ALERT SERVICE BULLETIN

429-16-29

MODEL AFFECTED: 429

SUBJECT: FWD CENTER FIREWALL WELDED ASSEMBLY 429-069-501-101/-109/-113 AND AFT CENTER FIREWALL WELDED ASSEMBLY 429-069-504-101/-103/-105/-107, INSPECTION AND REPAIR OF

Figure 4 – Part II - C (Sheet 1 of 5)

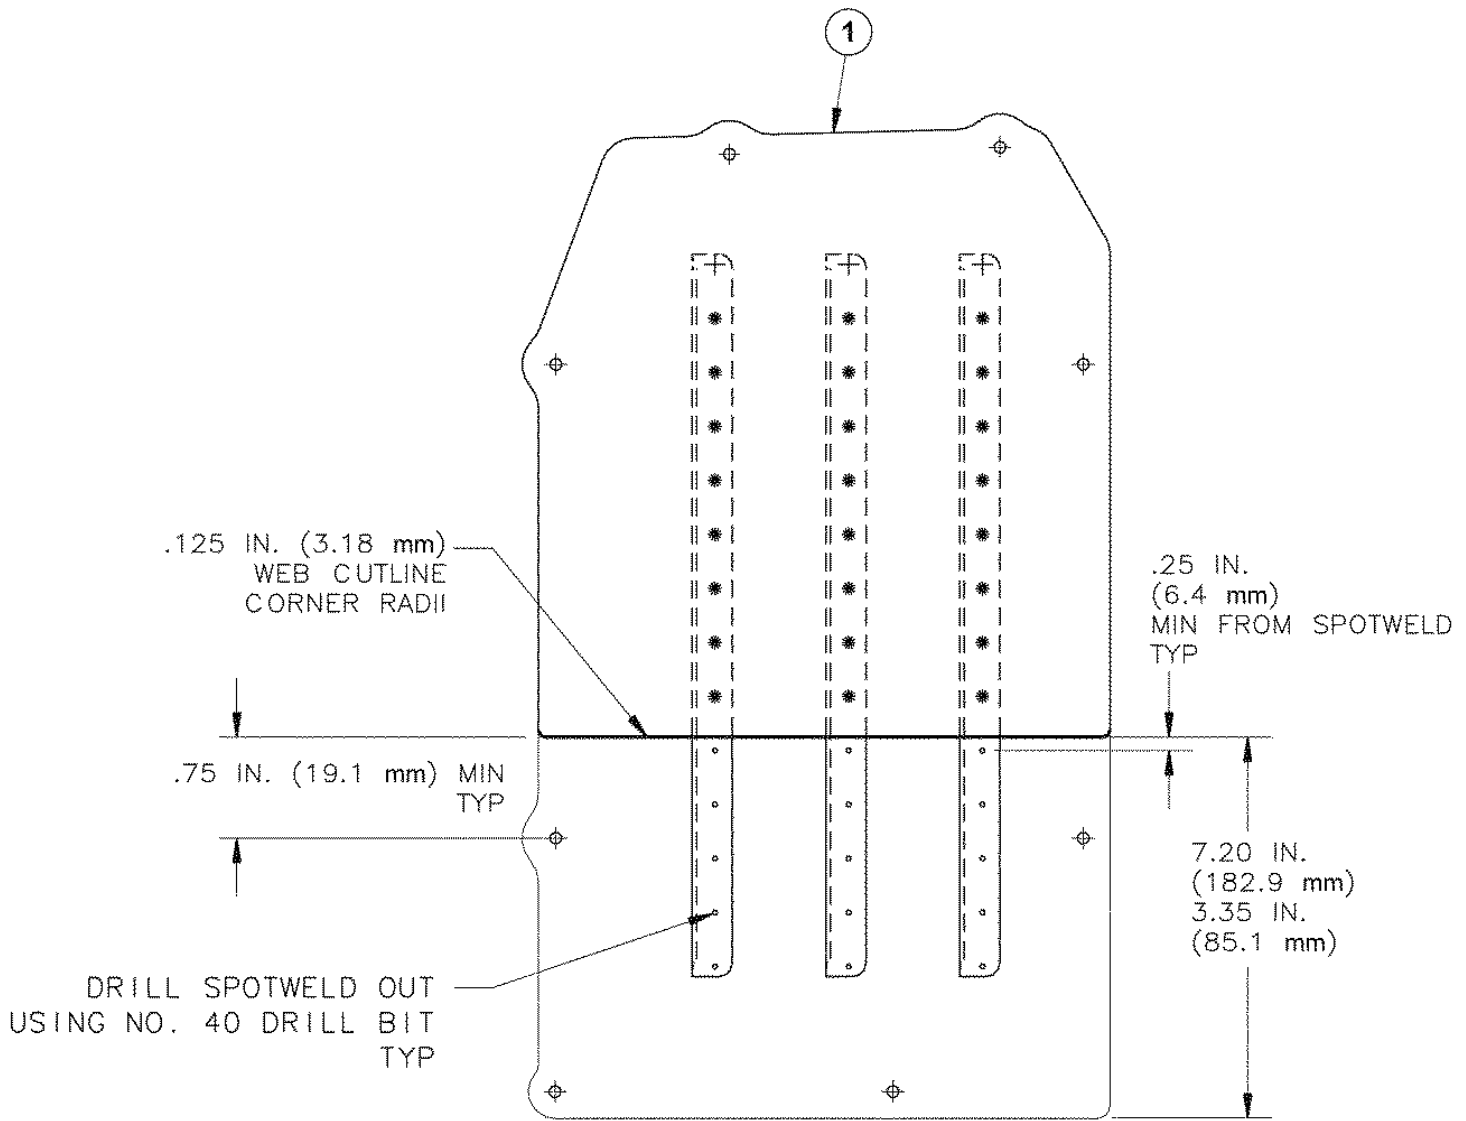
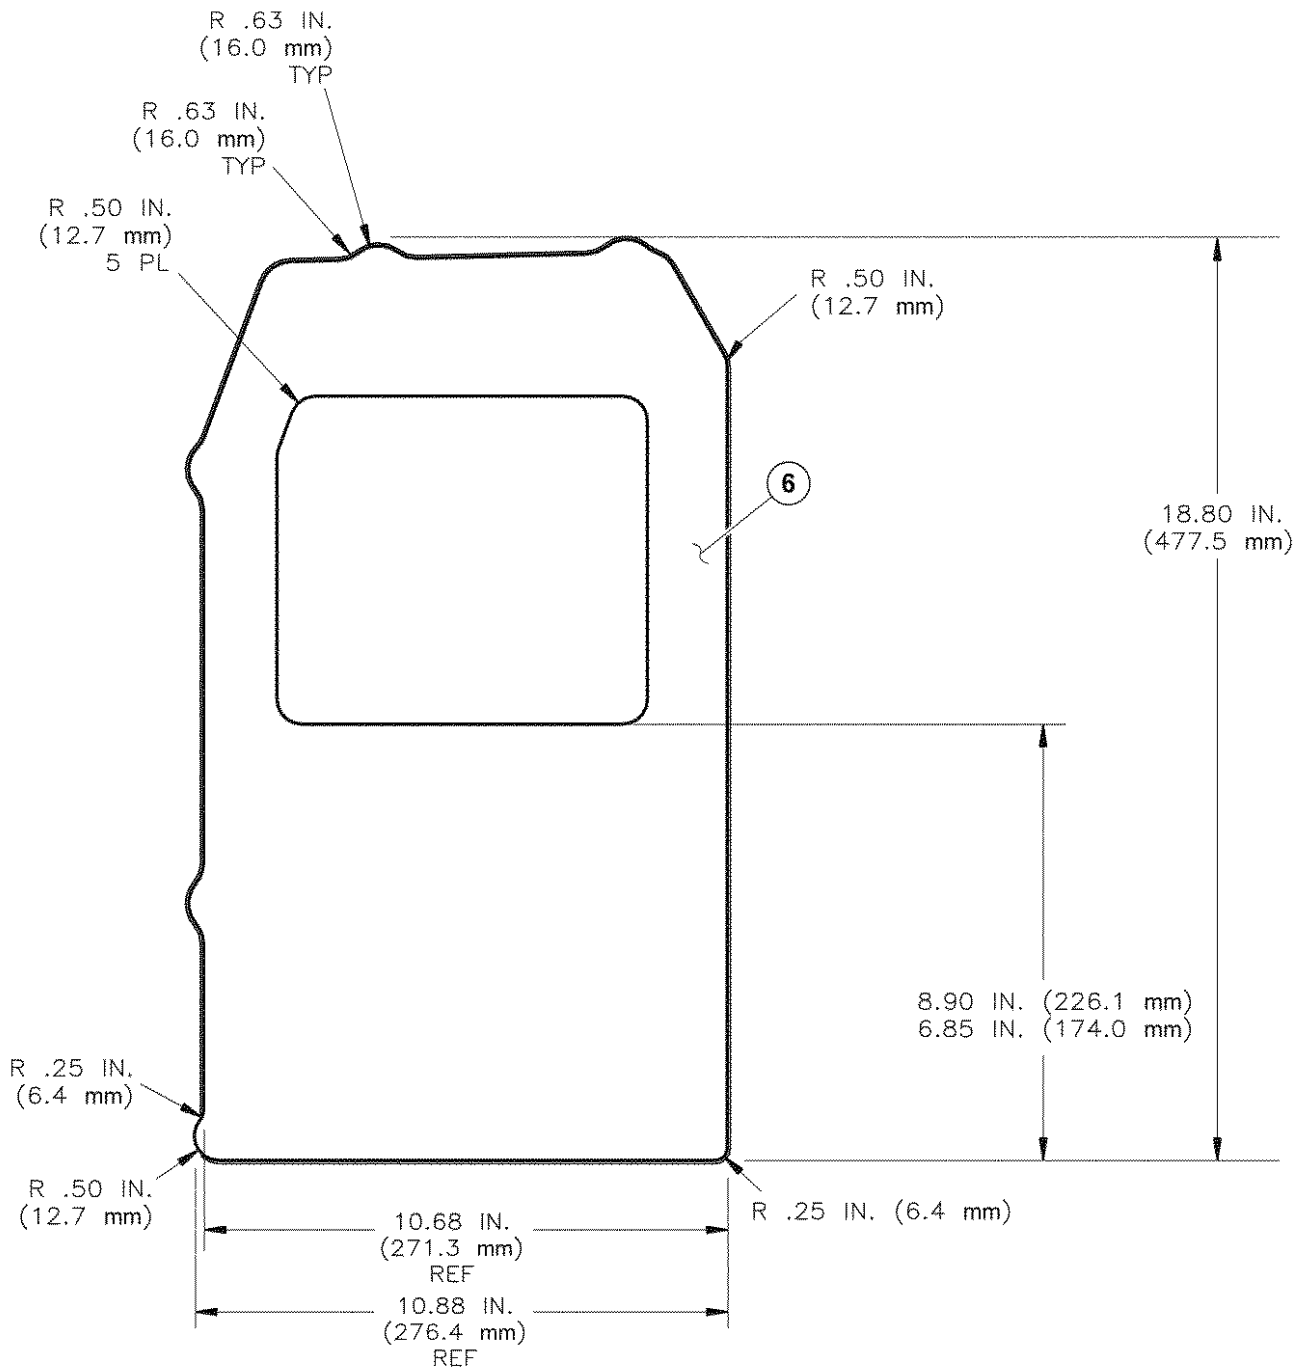
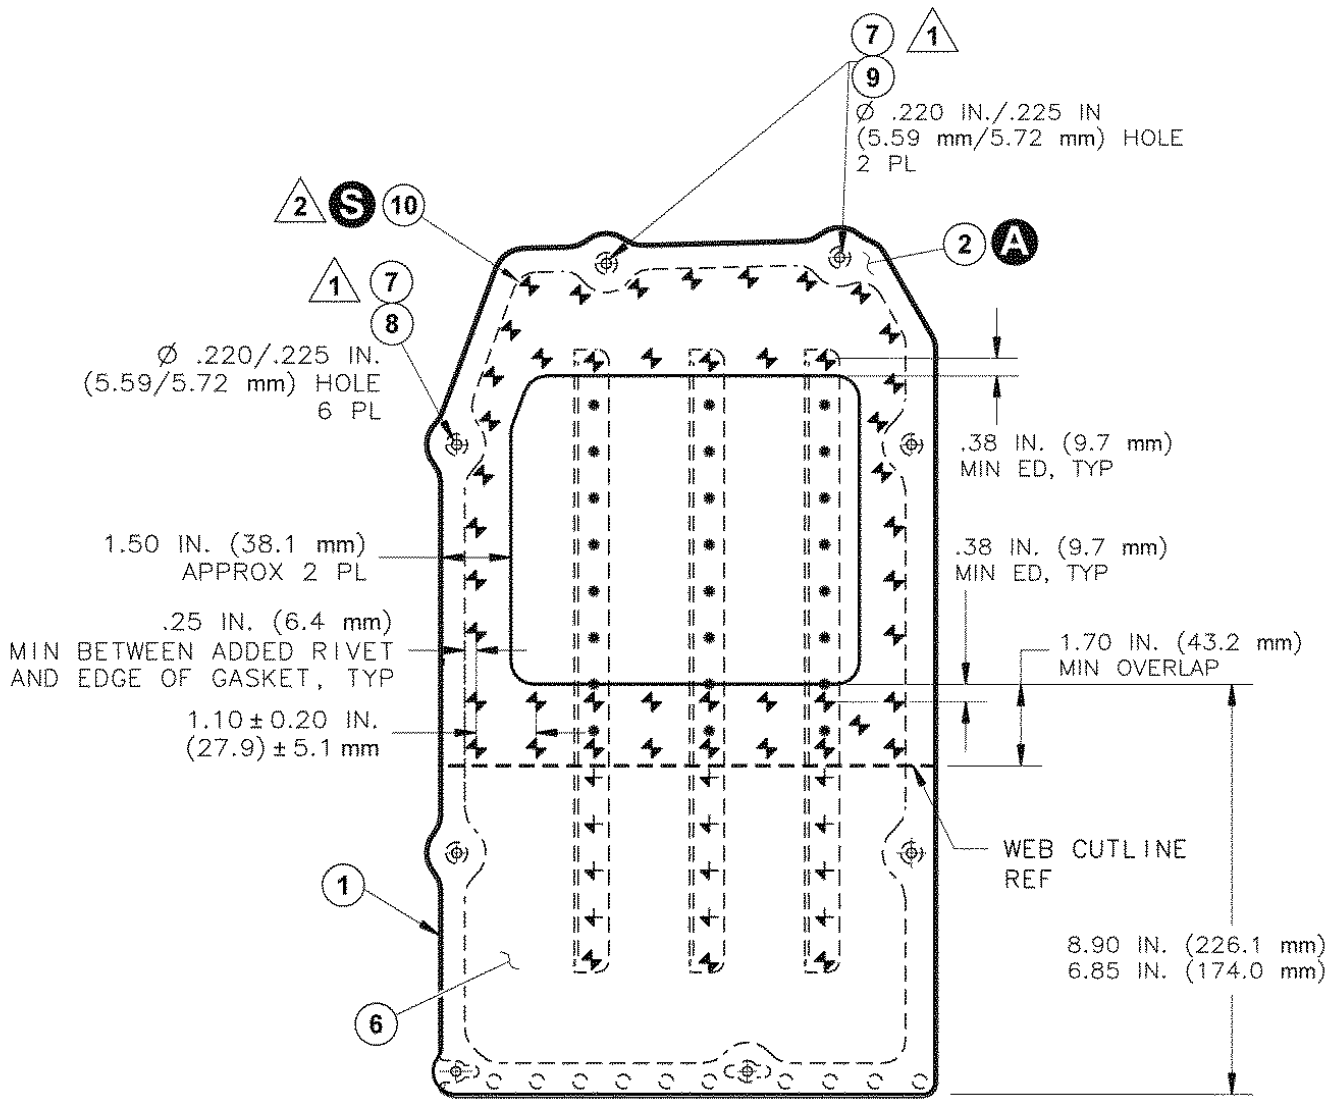
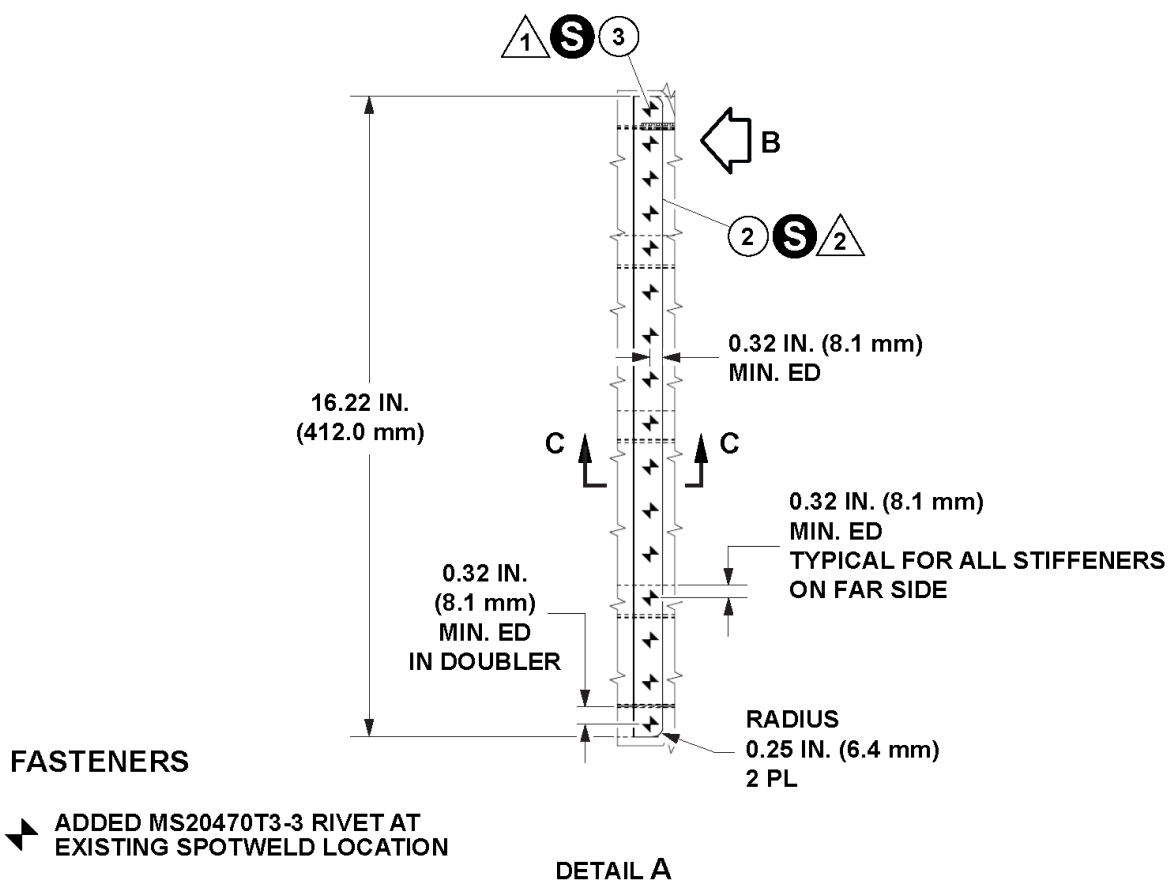
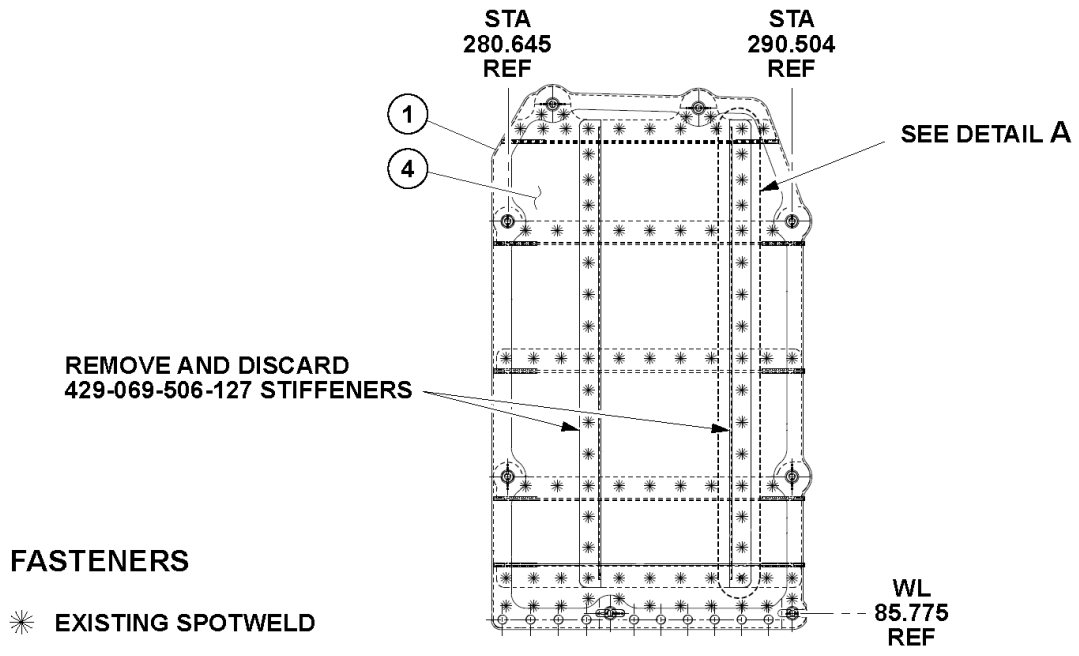
- e. If cracks are detected on the AFT center firewall welded assembly 429-069-504-105, comply with **Part II - C** (Figure 4), if not previously accomplished.

Do not remove more material than required. Only remove the damaged portion of the web while respecting the dimensions shown in Detail A.

3. Remove the existing fasteners on the end of each stiffener (5) (Detail A).
4. Drill through spot welds using a No. 40 drill bit to detach the AFT center firewall welded assembly (1) from the stiffeners (5) (Detail A).

5. Cut out and remove the damaged portion of the AFT center firewall welded assembly (1). Cutout to be as per the dimensions shown in Detail A.
6. Inspect the exposed area of the AFT center firewall welded assembly (1) and the surrounding structure for corrosion, chafing, cracks, or damage. Make sure the spot welds adjacent to the cutlines are intact (Detail A). If any such damage exists, submit to PSE with details describing the extent of the damage.

7. Fabricate the web (6) using the repair sheet 150-021-34C1-2 and dimensions shown in Detail B and Detail C. The web must be a replicate of the AFT center firewall welded assembly (1). Make sure the web overlaps the AFT center firewall welded assembly cutout by a minimum of 1.70 inches (43.2 mm) (Detail C).

8. Locate the web (6) in position and drill to accommodate the new fastener locations (Detail C). Make sure proper edge distance and spacing is achieved. Refer to [Table 3-28 of ALL-SRM](#) for appropriate fastener hole sizes.

9. Transfer the existing fastener holes on the end of each stiffener (5) into the web (6) while also maintaining the same hole diameter as the originals (Detail C).

10. Transfer the eight 0.220 to 0.225 inch (5.59 mm to 5.72 mm) diameter holes into the web (6) (Detail C).

12. Locate and secure the web (6) using fasteners (10), as shown in Detail C.

13. Reinstall the gasket (2) using bonding adhesive (C-325) as per the BHT-ALL-SPM, Section 7-5.
14. Reinstall the grommets (7) and the studs (8 and 9) on the AFT center firewall welded assembly (1) (Detail C).

15. Overcoat all the grommets (7) in the gasket cavity with firewall sealant (C-353) to prevent further chafing. Allow to dry.
16. Rotate the studs (8 and 9) to ensure proper installation in the receptacles.

17. Seal all edges of the repair area on the AFT firewall welded assembly (1) with firewall sealant (C-353). Make sure the AFT firewall welded assembly and the web (6) are sealed and that the rivet heads and the shop heads are overcoated with firewall sealant (Detail C).

Figure 5 – Part II - D (Sheet 1 of 2)

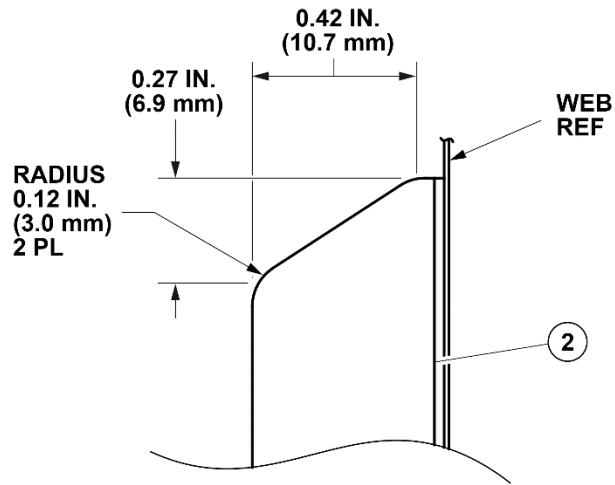
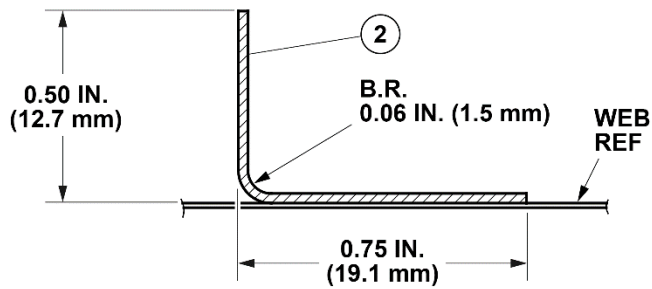
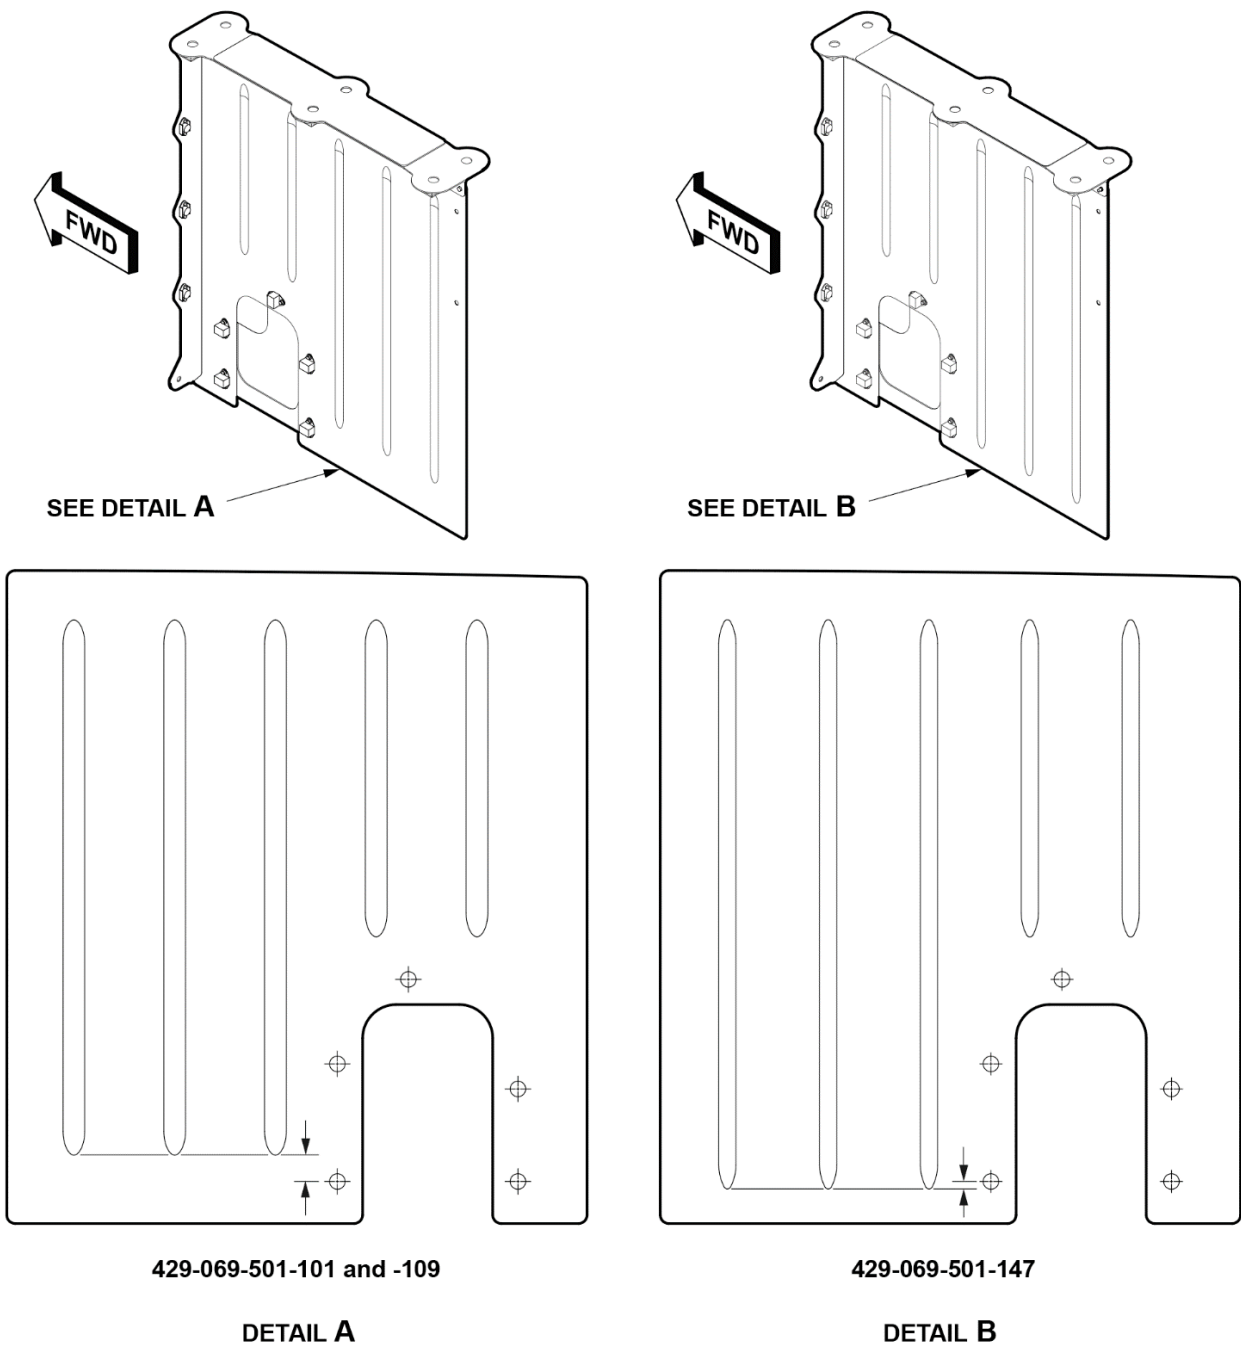
Revision B of this bulletin addresses the 429-069-501-147 FWD Center Firewall and the 429-069-504-107 AFT Center Firewall which were introduced at helicopter serial numbers 57340 and subsequent. While the 429-069-501-147 FWD Center Firewall has proven to be reliable, the 429-069-504-107 Aft Center Firewall continues to see cracking at the extremities of the vertical stiffeners.

- f. If cracks are detected on the AFT center firewall welded assembly 429-069-504-107, comply with **Part II - D** (Figure 5).
5. Reinstall the transmission cowl assemblies 600EL and 600ER ([DMC-429-A-53-00-00-44A-720A-A](#)) and the aft engine cowl assemblies ([DMC-429-A-53-00-00-47A-720A-A](#)).

When removing the stiffeners (2), be careful not to damage the web (4). Drill through the spotwelds using a #40 drill bit to detach the stiffeners from the web and doubler. It may be necessary to carefully grind what remains of the spotwelds on the stiffeners (2) after drilling to successfully remove them.

2. Remove the 429-069-506-127 vertical stiffeners from the welded assembly (1).

3. Inspect the exposed areas of the welded assembly (1) for corrosion, cracks, or damage. If the welded assembly (1) is damaged, submit a structural repair request to productsupport@bellflight.com ([IL GEN-22-154](#)).
4. Fabricate two stiffeners (2) as shown in Detail A, View B and Section C-C, using repair material 150-021-35C1-2. Make sure to maintain a 0.06 inch (1.52 mm) minimum bend radius.
5. Position the two stiffeners (2) on the welded assembly (1). Locate and drill holes using the drilled-out spotweld holes in the welded assembly. Maintain proper edge distance and spacing. Refer to [Table 3-28 of ALL-SRM](#) for the appropriate fastener hole size.

7. Locate and secure the stiffeners (2) using fasteners (3), as shown in Detail A.
8. Seal all edges of both stiffeners (2) on the AFT firewall welded assembly (1) with firewall sealant (C-353). Make sure the AFT center firewall welded assembly (1) and the web (4) are sealed and that the rivet heads and the shop heads are overcoated with firewall sealant (Detail A).
9. Install the repaired Aft center firewall welded assembly (1) on the helicopter ([DMC-429-A-71-30-00-03A-720A-A](#)).
10. Make an entry in the helicopter logbook and historical service records indicating compliance with **Part II – D** of this ASB.

Figure 6 – FWD Center Firewall Part Number Identification

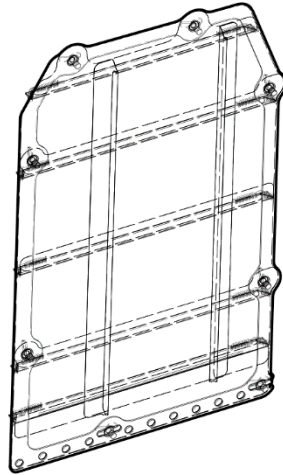
If the part numbers are no longer legible, refer to Figures 6 and 7 to correctly identify which firewalls are installed.

1. The 429-069-501-147 FWD Center Firewall can be differentiated from the 429-069-501-101 and -109 by the length of the beads as shown above.
2. The 429-069-501-113 FWD Center Firewall has stiffeners instead of beads.
